# UNITED STATES PATENT AND TRADEMARK OFFICE

APPLICATION NO.	FILING DATE	FIRST NAMED INVENTOR	ATTORNEY DOCKET NO.	CONFIRMATION NO.
10/523,067	08/05/2005	Felix Blank	510.1117	7491
23280 7590 12/24/2009 Davidson, Davidson & Kappel, LLC 485 7th Avenue 14th Floor New York, NY 10018				
EXAMINER RADEMAKER, CLAIRE L				
ART UNIT		PAPER NUMBER		
1795				
MAIL DATE		DELIVERY MODE		
12/24/2009		PAPER

### Office Action Summary

**DETAILED ACTION**

The following illustration (modified Figure 16 of Iwase et al.) is provided for clarification:

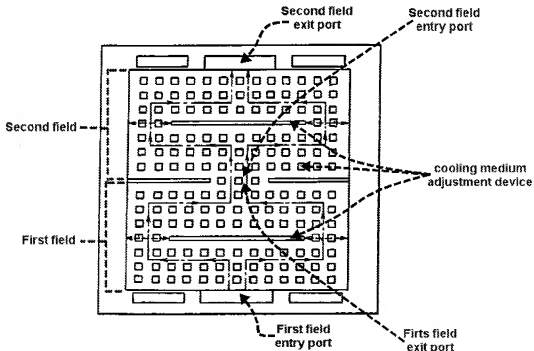
With regard to claims 21-23, Mizuno et al. fails to teach the concept of the first and second fields each including a cooling medium entry port and a cooling medium exit port for the cooling medium, where the cooling medium exit port of the first field is connected to the cooling medium entry port of the second field, or teach a cooling medium adjustment device configured to adjust one of a flow rate and a condition of the cooling medium separately for the first and second fields.

Iwase et al. teaches the concept of a fuel cell (col. 7, lines 1-6) comprising a membrane electrode assembly (MEA) (51 & 52 & 53, col. 7, lines 7-9), a guide passage structure for distributing a cooling medium (col. 16, lines 28-43; Figure

16), and a flowfield plate having first and second fields (col. 16, lines 28-43; Figure 16), where the first and second fields each include a cooling medium entry port and a cooling medium exit port (col. 16, lines 28-43; Figure 16) for the cooling medium, where the cooling medium exit port of the first field is connected to the cooling medium entry port of the second field (col. 16, lines 28-43; Figure 16), and teaches the use of cooling medium adjustment device (613 and/or 655 & 656, col. 16, lines 28-43; Figure 16) configured to adjust a flow rate of the cooling medium separately for the first and second fields (col. 16, lines 28-43; Figure 16).

It would have been obvious to one of ordinary skill in the art at the time of the invention to replace the flowfield plate cooling medium flowfield structure of

Mizuno et al. with the flowfield plate cooling medium flowfield structure of Iwase et al. in order to improve the performance of the fuel cell due to improved diffusibility and flow rate (col. 16, lines 28-43 & col. 15, lines 51-54).
